Application for Works Approval

Works Approval Number W6950/2024/1

Applicant Andy Well Mining Pty Ltd

Premises Andy Well Gold Project
Mining Tenement M51/870
MEEKATHARRA WA 6642

Figure 3: Model calculated flow path at Suzie IPTSF

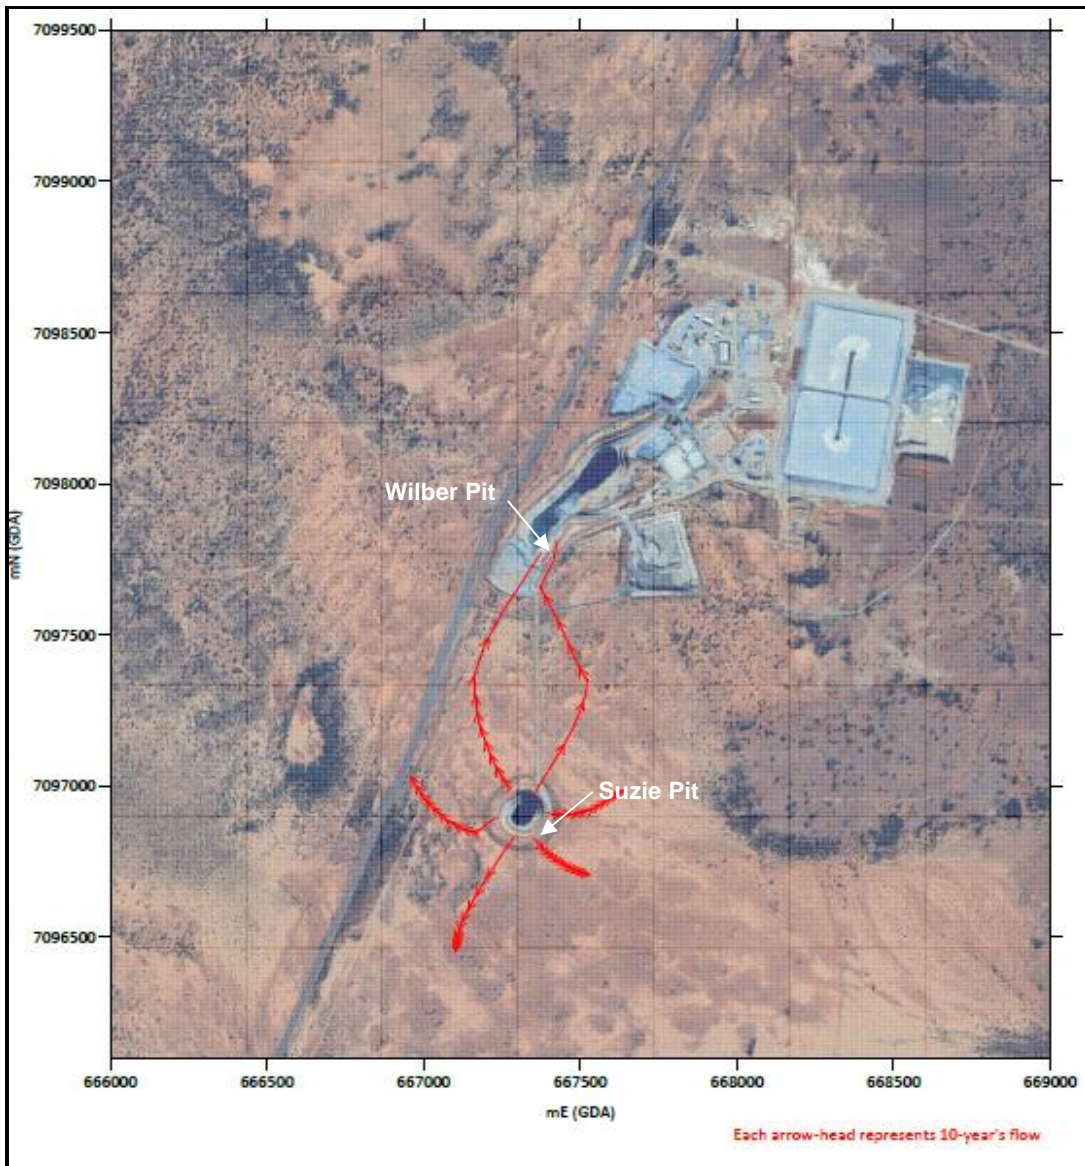
Numerical flow-path modelling results submitted by the applicant for a worse-case scenario of no reduction in aquifer permeability resulting from tailings emplacement, and a continuing source of water for seepage from the pit, indicates that groundwater would flow radially from Suzie IPTSF:

- to distances of 220 m to 300 m across-strike after 100 years;
- to 400 m along-strike to the south-west; and
- take 70 to 100 years to reach Wilbur pit 830 m to the north (see Figure 3 above).

The application was referred internally to the department's Principal Hydrogeologist who suggests the applicant has underestimated the extent to which Arsenic discharge could take

- Overpressure that would be produced in porewater during consolidation of the tailings material, would “squeeze” a more significant amount of water from the materials into groundwater than would be expected from passive drainage through a matrix with a low permeability. This forced discharge of contaminated porewater would continue until the pressure differential between the tailings porewater and surrounding groundwater dissipates, which could take longer than 5 years; and

- Geochemical testing of the tailings materials only assessed the potential to release Arsenic under chemically oxidising conditions (i.e., under conditions when they will be exposed to atmospheric oxygen). However, it is likely that some of the tailings will be submerged below the water table as the mine void is progressively filled, and as nearby mine dewatering ceases. Under these conditions, the release of Arsenic from submerged tailings can increase (see a discussion of this issue in Mahoney et al., 2005).

The department’s Principal Hydrogeologist also considers the applicant has underestimated the extent to which there are environmental receptors near Suzie IPTSF that could be affected by Arsenic contamination of groundwater. The department’s Principal Hydrogeologist considers that deep rooted vegetation could access contaminated groundwater in areas where the water table is within approximately 5 m of the land surface. Under these conditions, vegetation would have the potential to bioaccumulate Arsenic which could then be transferred to grazing livestock and wildlife. The risk of vegetation bioaccumulating significant levels of Arsenic would be particularly high at sites where the Arsenic concentrations in groundwater near the water table exceed the *ANZECC and ARMCANZ 2000* long-term irrigation (LTV) criterion of 100 µg/L.

Considering the above factors, the department has determined the applicant must have suitable strategies to manage potential impacts of Arsenic contamination on nearby environmental receptors. The department notes the applicant has proposed an increase in decant water recovery, reduce tailings discharge rates and utilise recovery bores to recover contaminated groundwater if groundwater levels are observed at or above 4 mbgl. Therefore, the department has determined to include the proposed applicant controls as conditions in the works approval with the exception of a groundwater level limit of 4 mbgl or above. The department considers that deep rooted vegetation could access contaminated groundwater in areas where the water table is within about 5 m of the land surface.
